Product Change Notification

Change Notification #: 117000 - 00
Change Title: Intel® Server System R1208WFTYS, PCN 117000-00, Label, System outer box J33994-001 stacking logo update, 1100W Power Supply Add URL to BIS mark
Date of Publication: June 14, 2019

Image 1. Power supply label before change

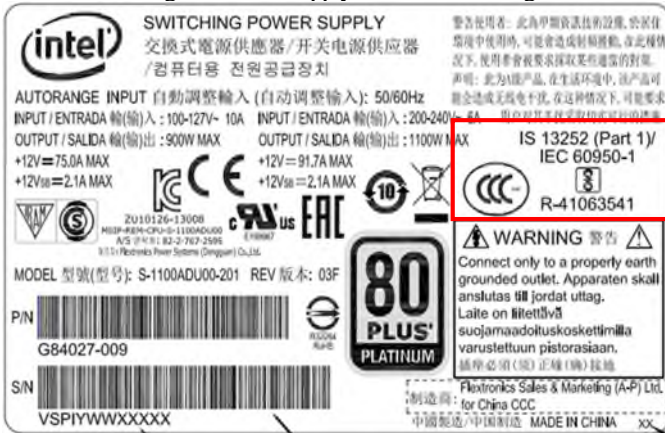
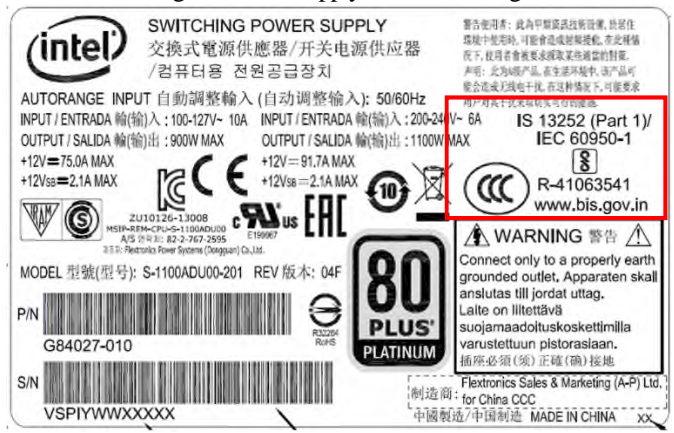
Intel is updating the label of the 1100 power supply. The new label includes a URL of the BIS mark and remove "S&E" inside the CCC logo.
